BLDG PERMIT NO. 70029

PLANNING CLEARANCE
 (Single Family Residential and Accessory Structures)
Community Development Department

565 Rio Borde Ct

LOT 3
 565 RIO BORDE
 LOT 3, FILING #1
 VISTA DEL RIO SUBDIVISION

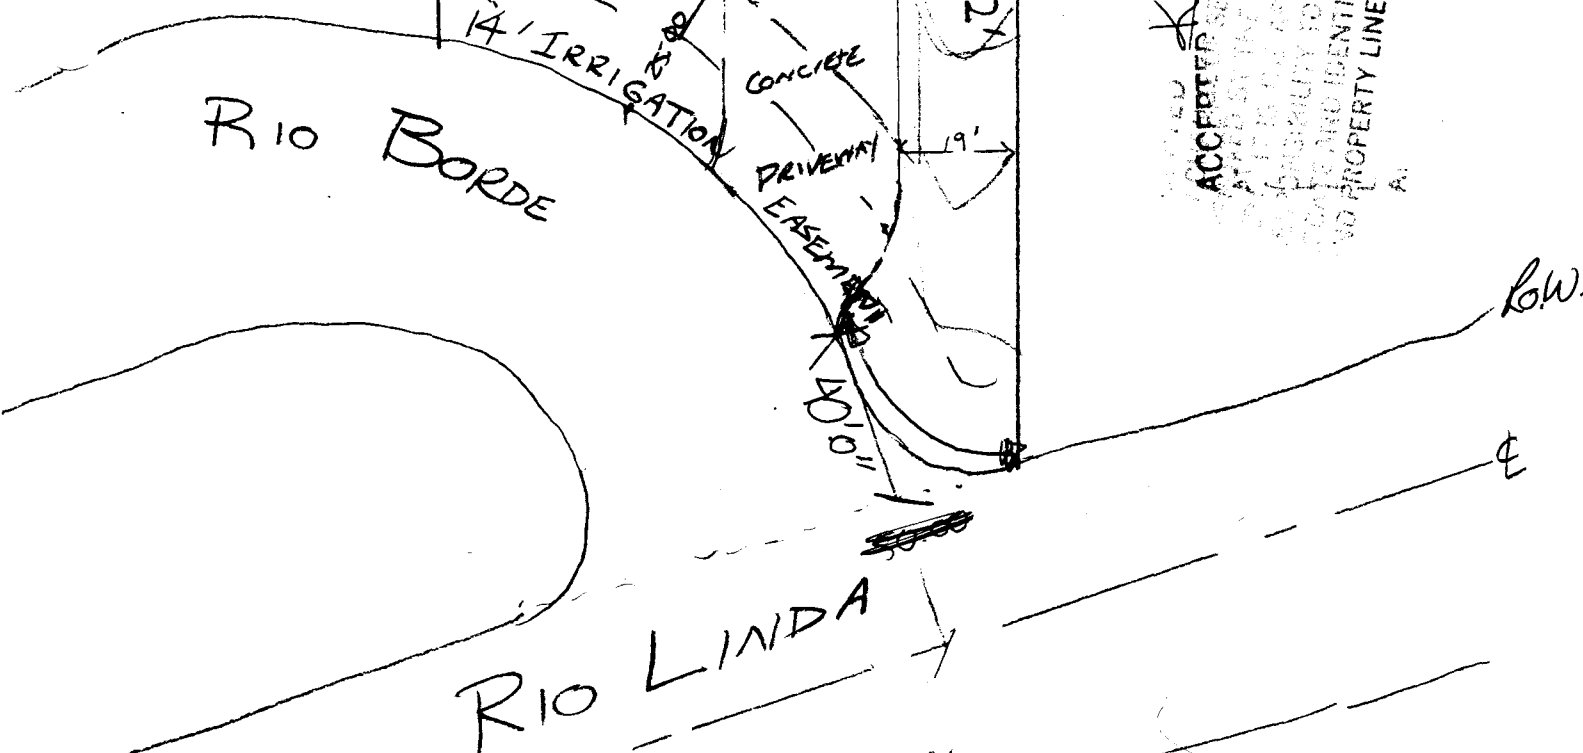
This drive doesn't meet
the requirement in the
TDS manual for separation
from a street. See attached!

Please flip the floor plan
and bring the drive off the
other side of the lot.
1st note

Drive is too
close to Vista Del
Rio which is residential

collector. Edge of drive
must be 50' off the
right of way line of Rio
Vista.

Rick Davis
If you flip the house
it should work.
2nd note

Drive OK
 Rick Davis
 6-2-99

FIGURE
1

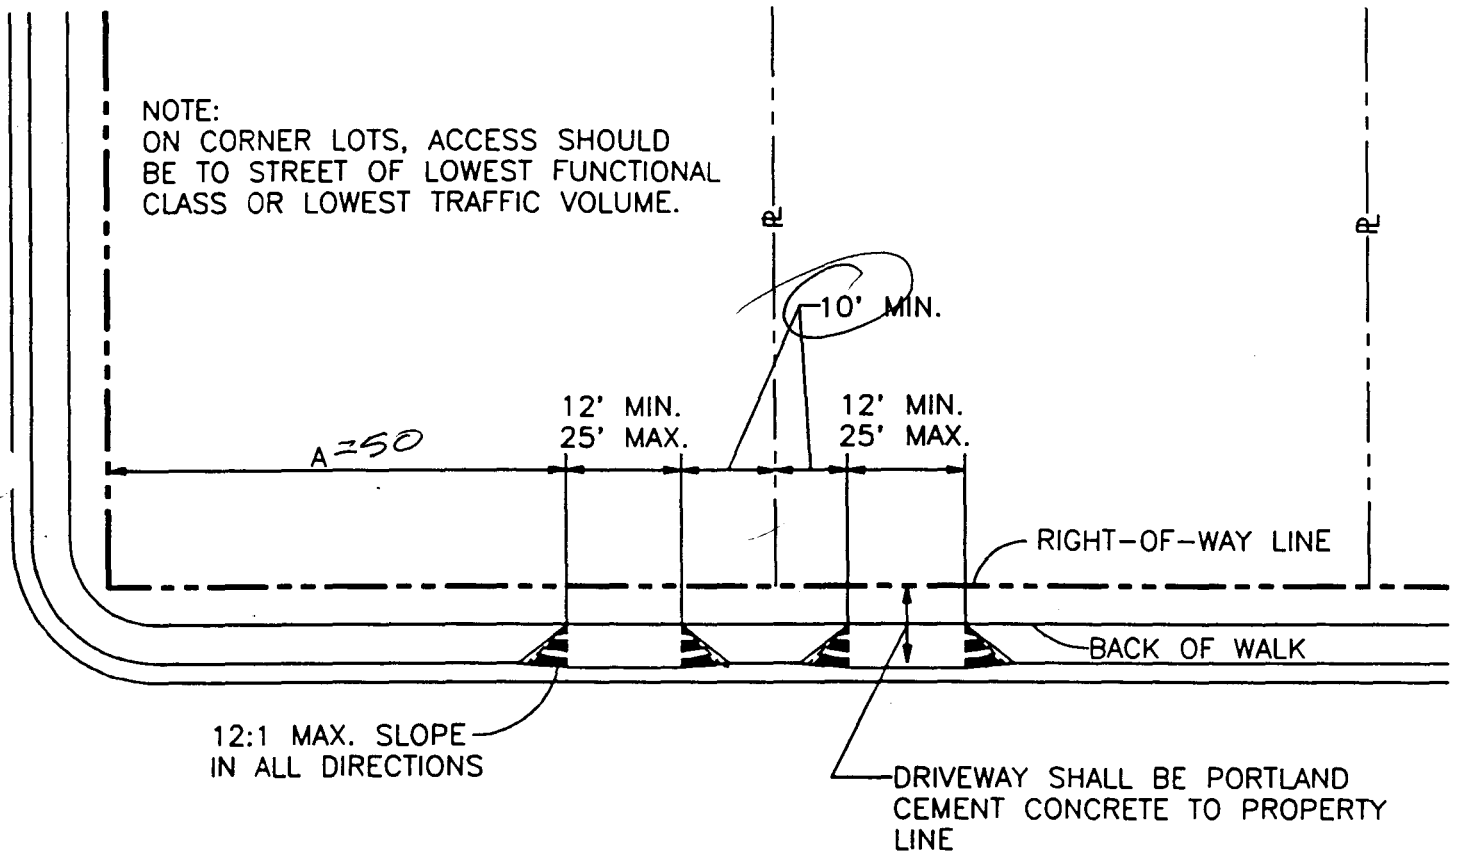
This part of kinda low is a minor collector
